Two Changes to SCE Simulation/Corrections

Michael Mooney
Colorado State University

ProtoDUNE Sim/Reco Meeting
August 19th, 2020

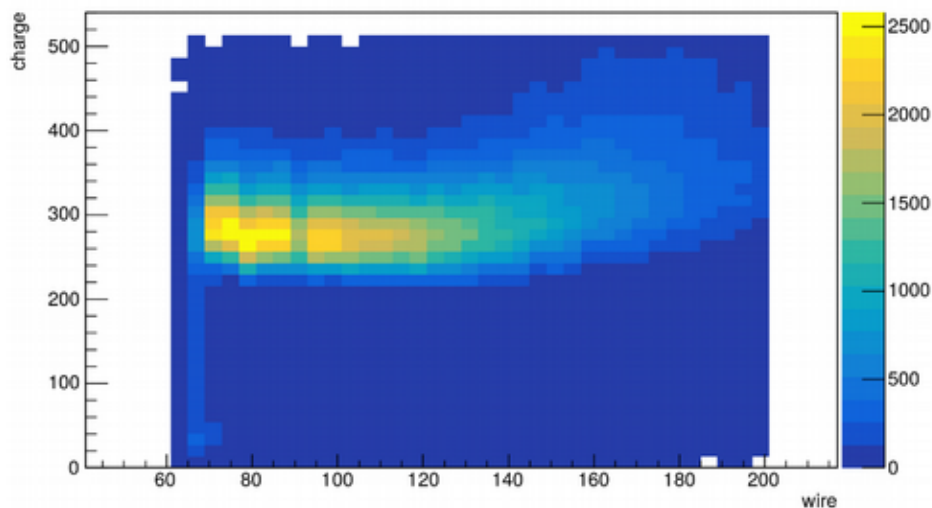
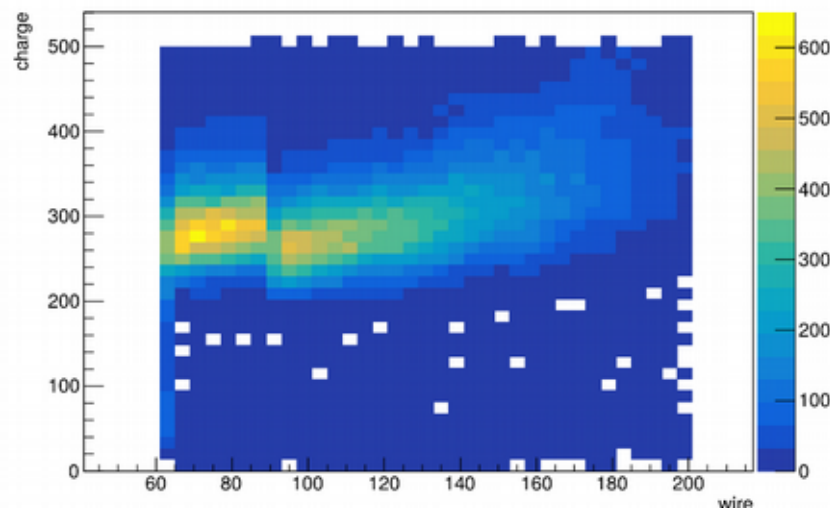
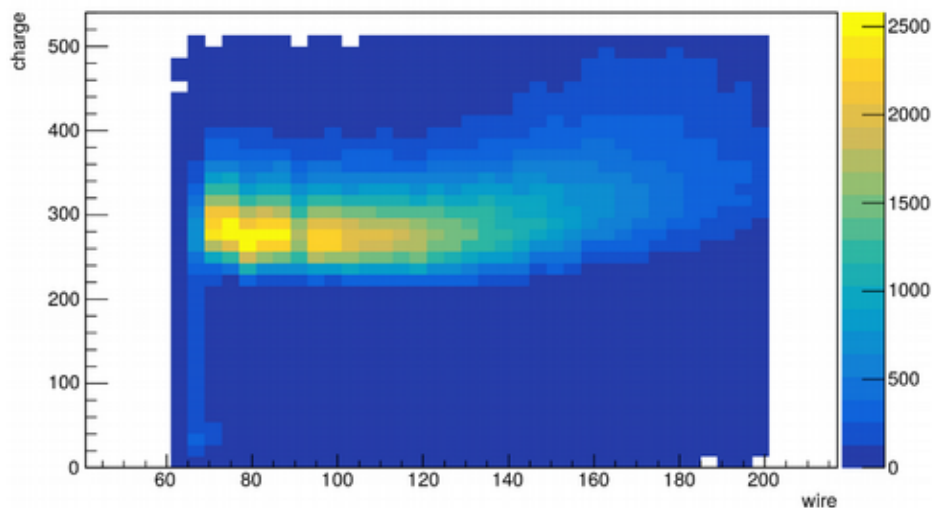
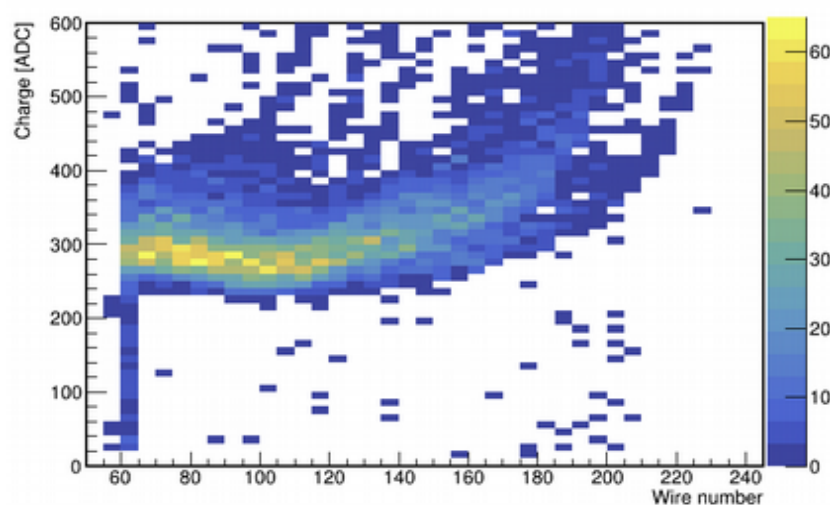
- ◆ Added spline-based interpolation to SpaceCharge service in `dunetpc`
 - Enable by changing `RepresentationType` to “`Splines_TH3`”
 - See `feature/mrmooney_SpaceChargeSplineInterp (v08_62_00)`
- ◆ Heng-Ye validated by running proton MC w/ fix – looks good!
 - Similar validations by Ajib w/ pions show consistent results

- ◆ Added spline-based interpolation to SpaceCharge service in `dunetpc`
 - Enable by changing `RepresentationType` to “`Splines_TH3`”
 - See `feature/mrmooney_SpaceChargeSplineInterp (v08_62_00)`
- ◆ Heng-Ye validated by running proton MC w/ fix – looks good!
 - Similar validations by Ajib w/ pions show consistent results

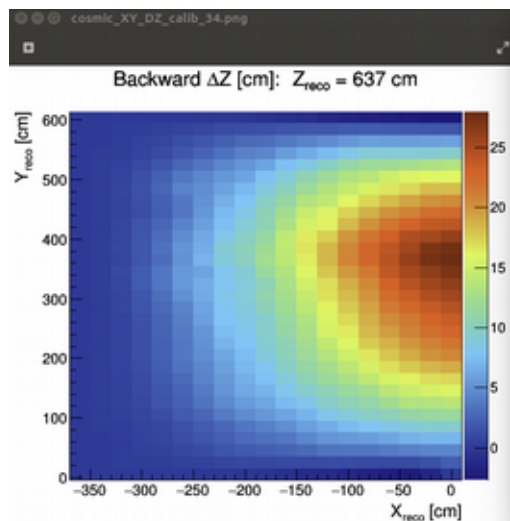
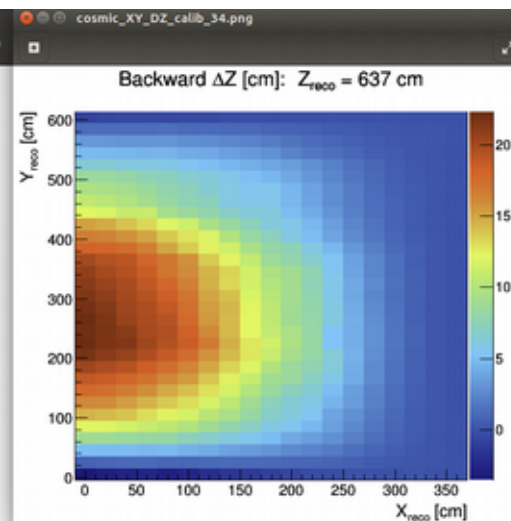
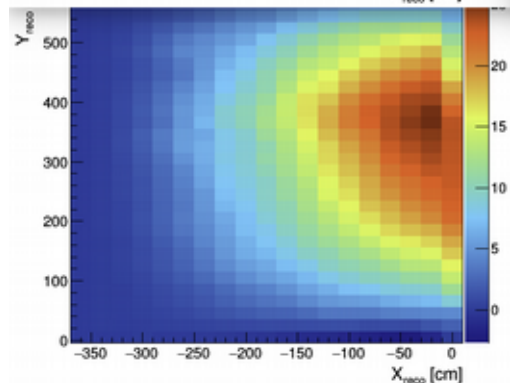
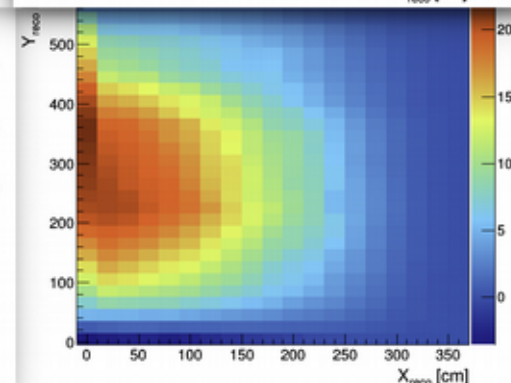
- ◆ Second problem impacts all three “v3” maps (forward spatial, backward spatial, E field) for **$-20 \text{ cm} < X < 20 \text{ cm}$**
 - Basically scale factors used to rescale simulation to match data are incorrect in this region – uses an average from two sides of cathode as opposed to the correct scale factors on each side
- ◆ Doesn’t impact us greatly as beam particles generally stay in negative drift volume, in particular $X < -20 \text{ cm}$
 - But track stitching and other studies right at cathode impacted!
- ◆ This has also now been fixed in new “v4” map
 - Change InputFilename to “SCE_DataDriven_180kV_v4.root”
 - Must be done in both g4 and reco steps (same as for using new spline-based interpolation)

- ◆ To showcase change, look at ΔZ in Y-X plane for $Z = 637$ cm
- ◆ Top row is new v4 map, bottom old v3 map – improvement!
